## ABBNEY PHASE 2 ROOF PLANT PROPOSALS

## 2.0 CONSENTED & PROPOSED ROOF PLANT COMPARISON

# 2.1 Roof Plan Comparison

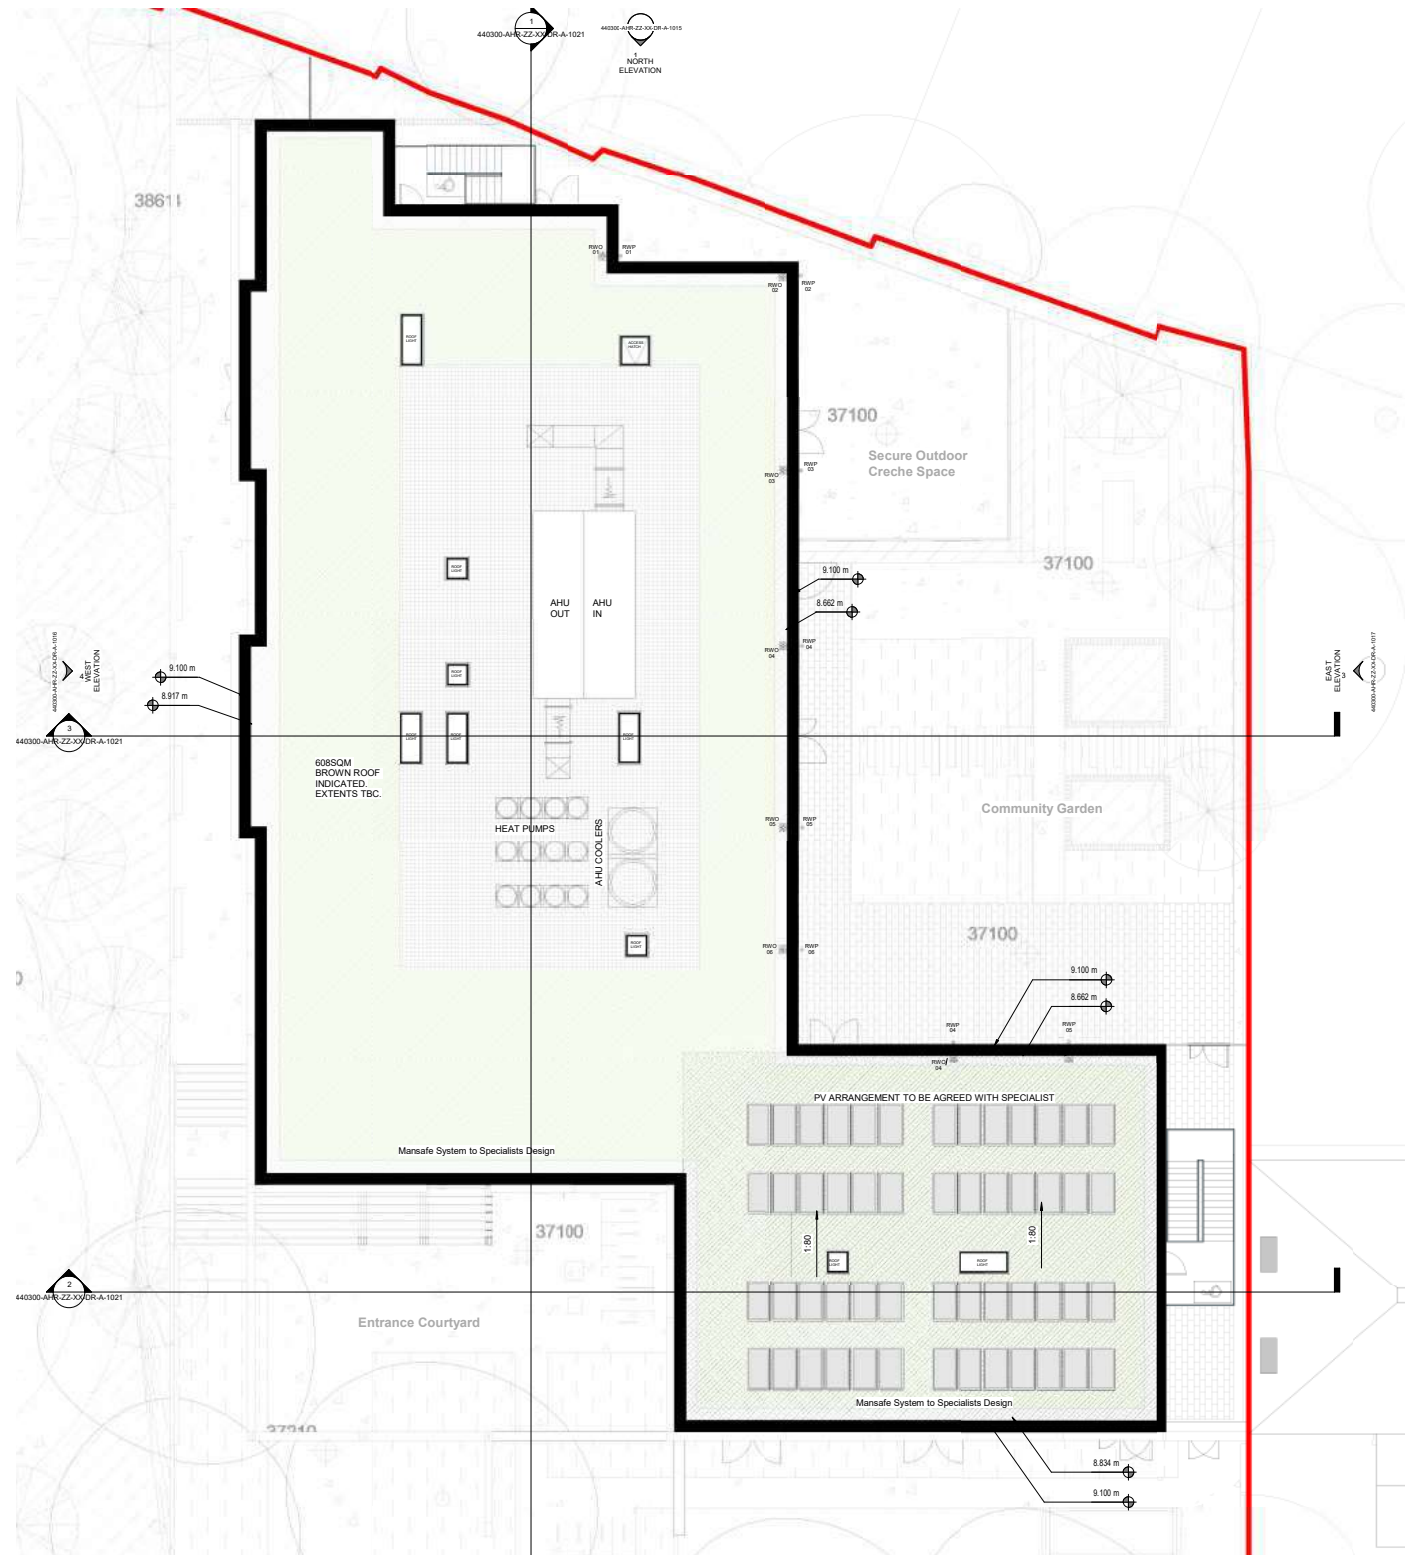
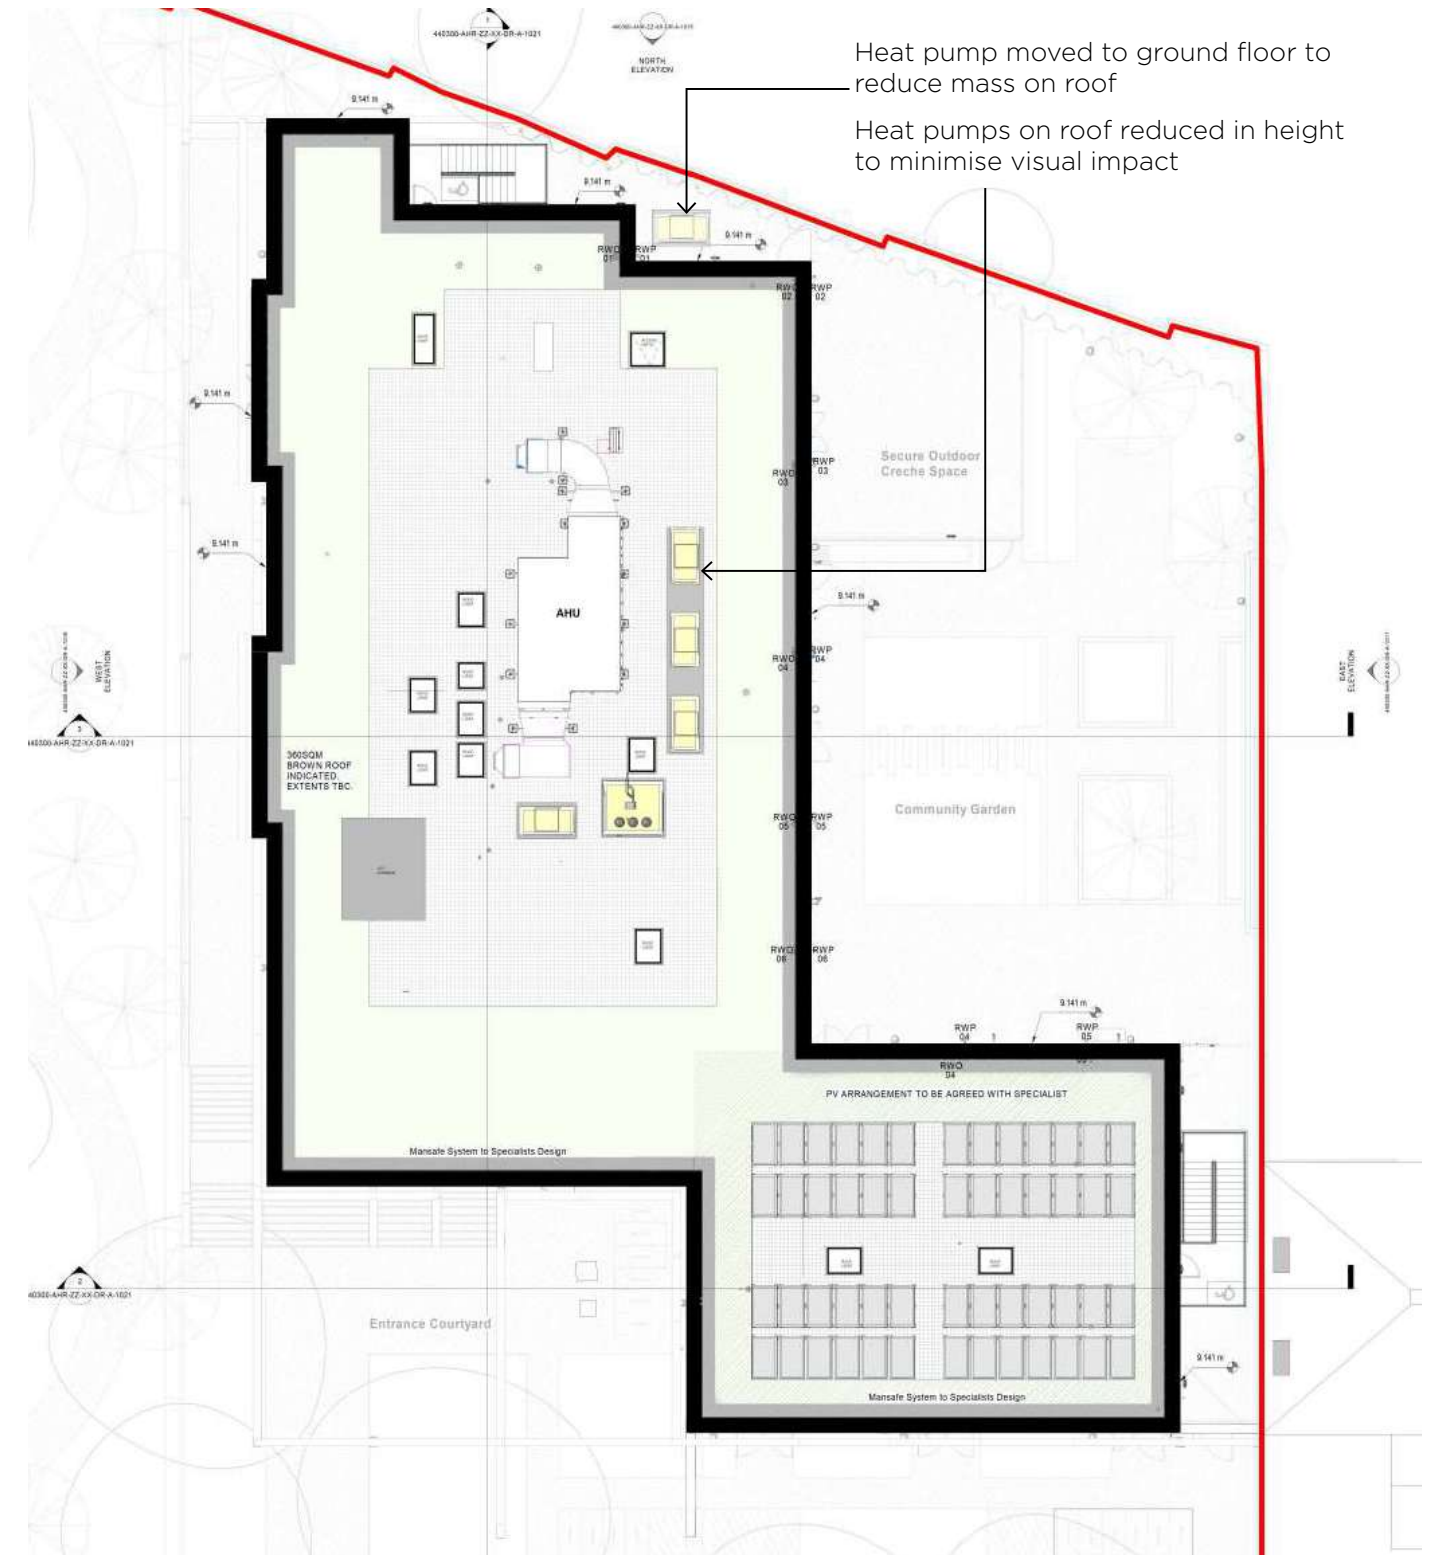
Post determination of the original planning application (2020/2486/P), the air distribution systems were designed, enabling static pressures to be calculated. Due to the static pressure requirements, larger fans were needed, increasing the plant size.

As a result of the required changes, the design team undertook a review of the proposed roof level plant to reconfigure and minimise any post-determination changes. The design team have reconfigured the roof plant, grouping heat pumps to reduce the coverage on the roof. In addition one heat pump has been removed from the roof and positioned at ground level. The ground floor heat pump is not visible from the surrounding properties (as indicated in the section opposite). The Acoustician has checked the proposed location and has confirmed that the acoustic ratings set out in the Acousticians planning reports have not been compromised.

## 2.2 South Elevation Comparison

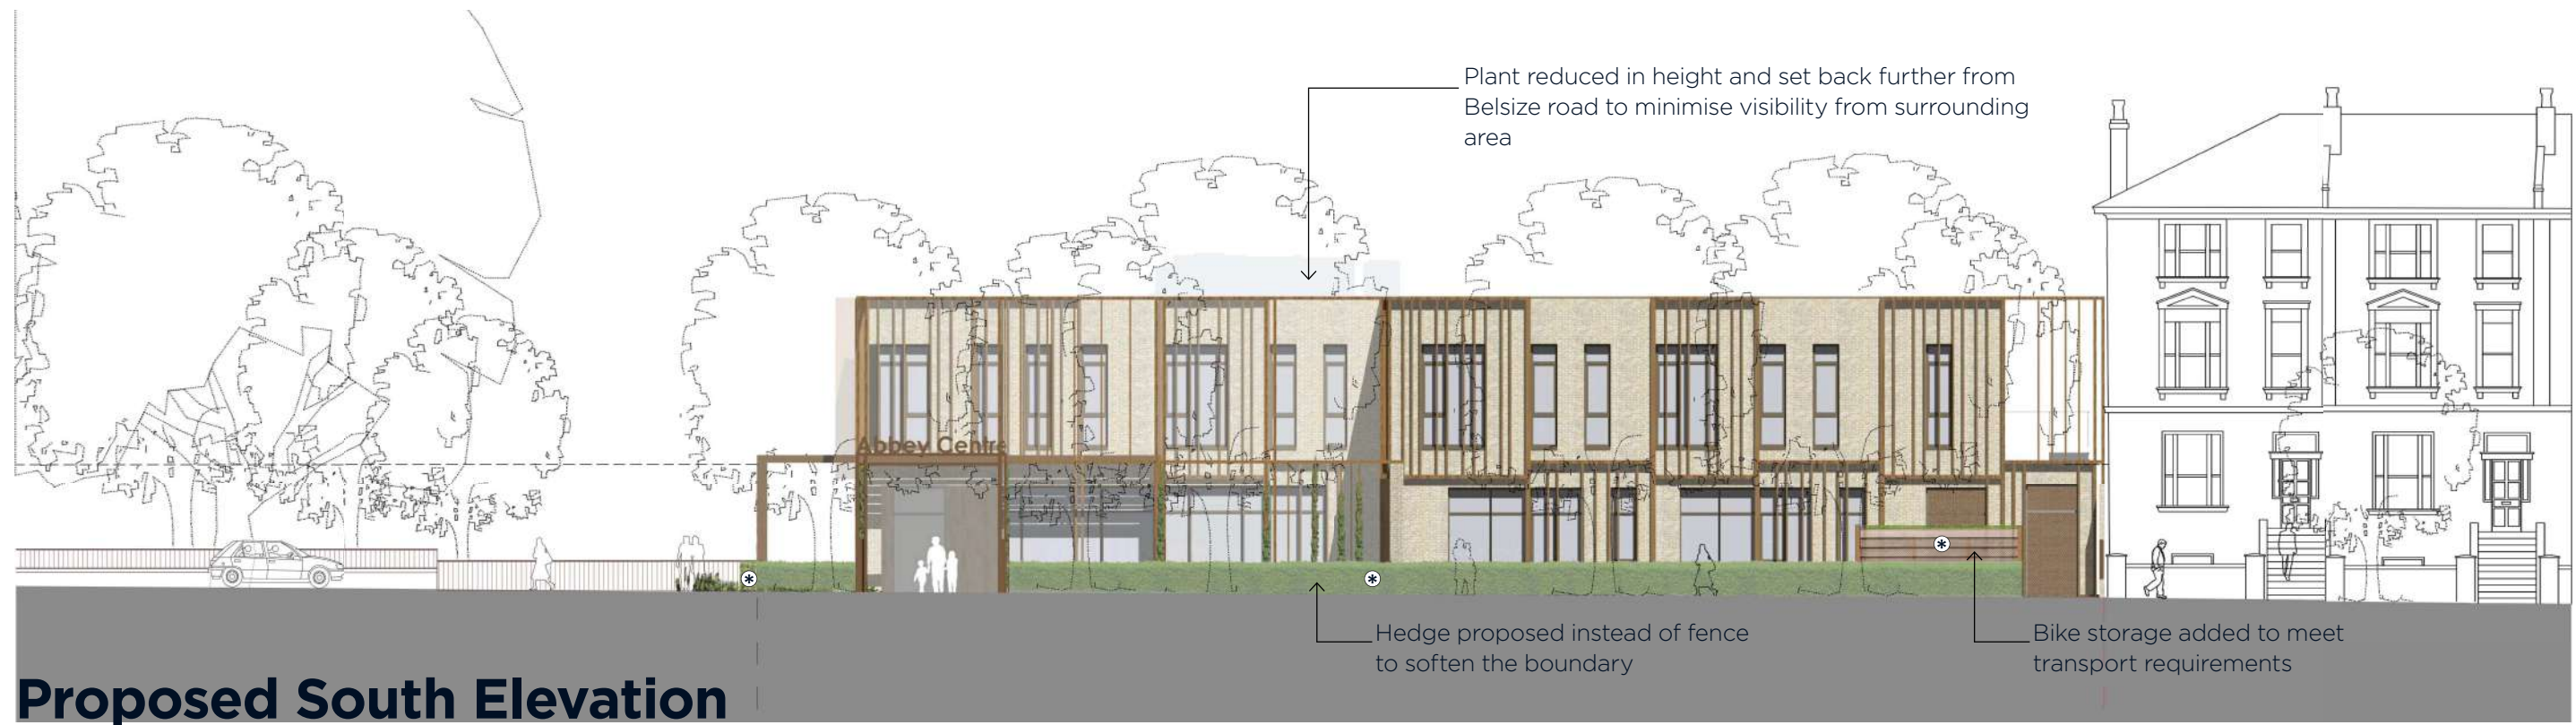
\*Please refer to final paragraph in section 1.0

## 2.3 West Elevation Comparison

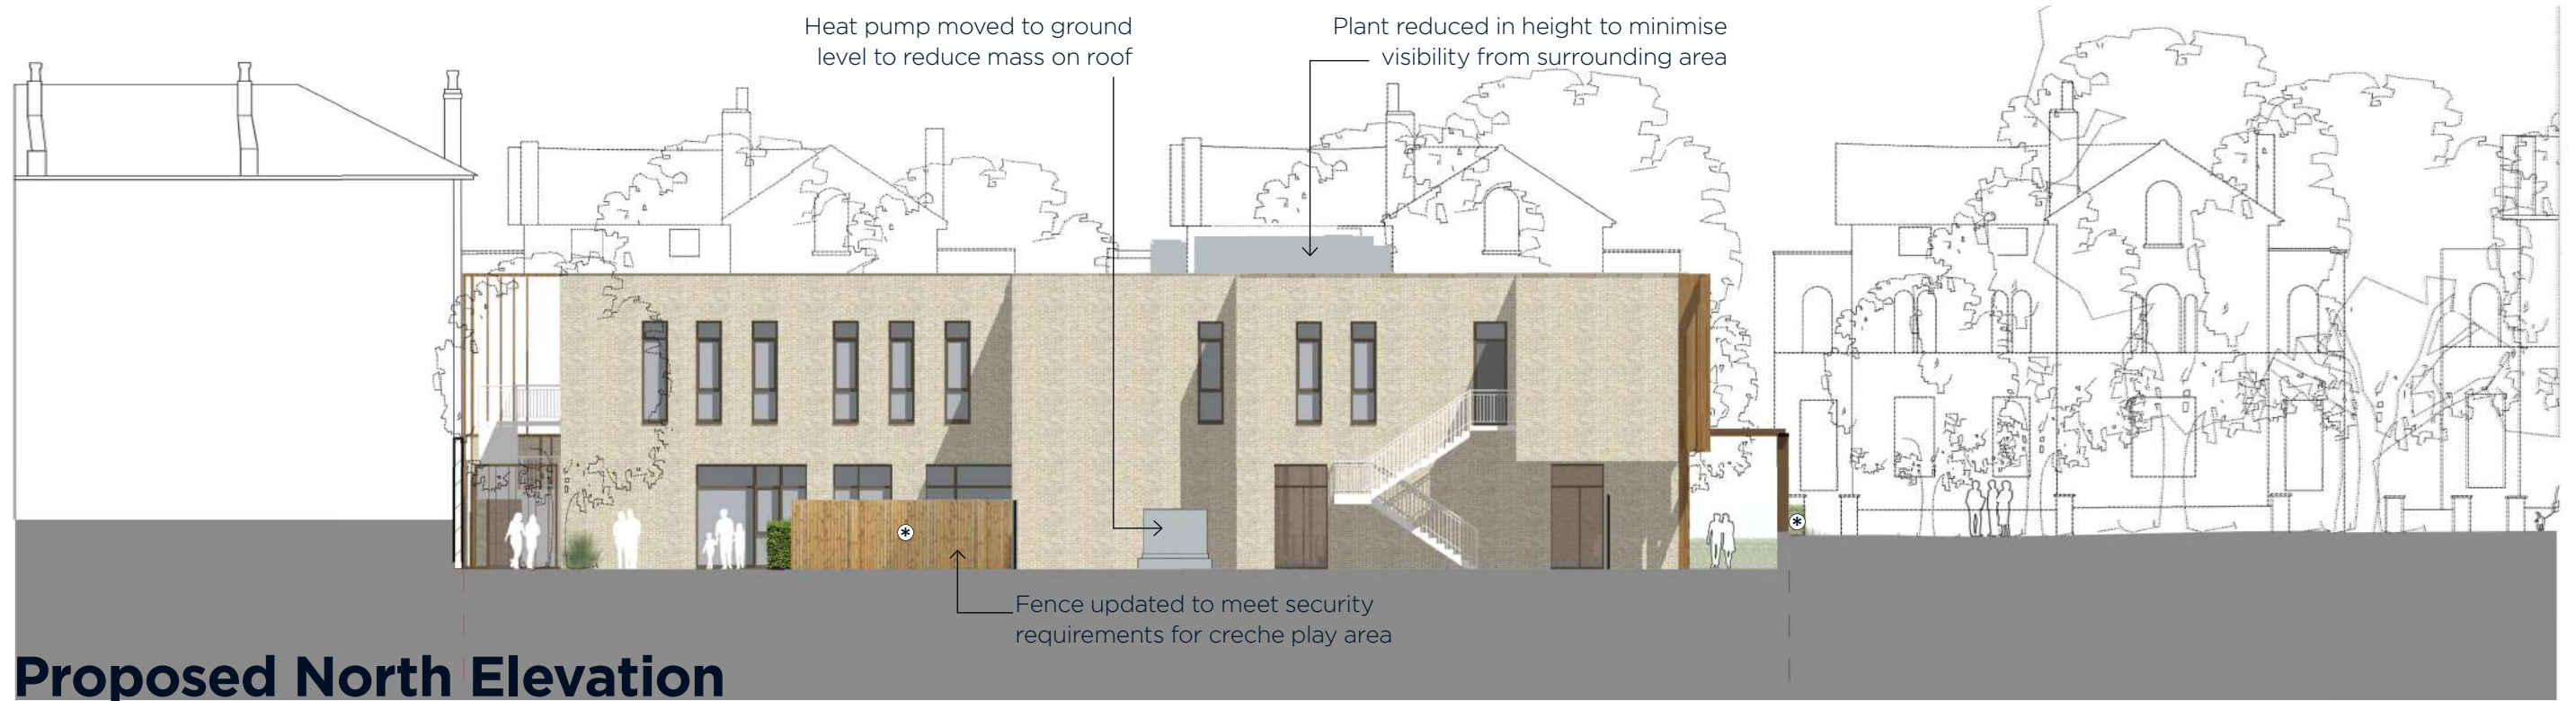
\*Please refer to final paragraph in section 1.0

## 2.4 North Elevation Comparison

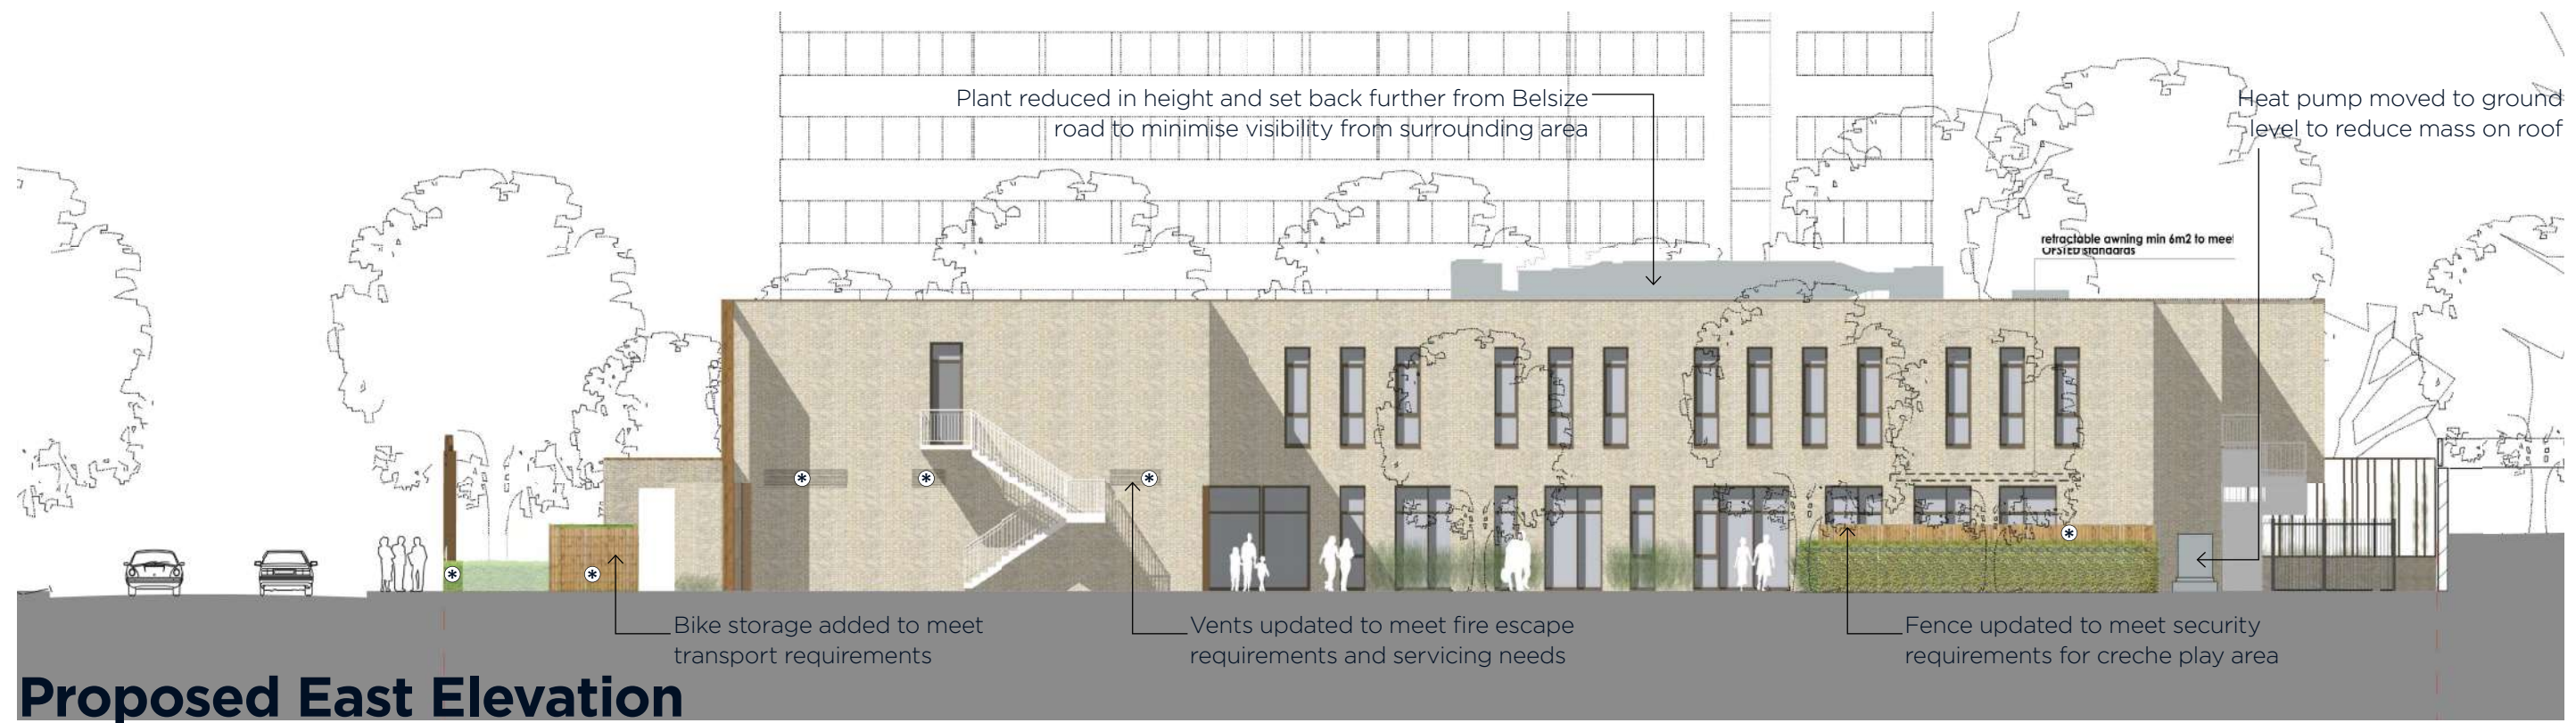
\*Please refer to final paragraph in section 1.0
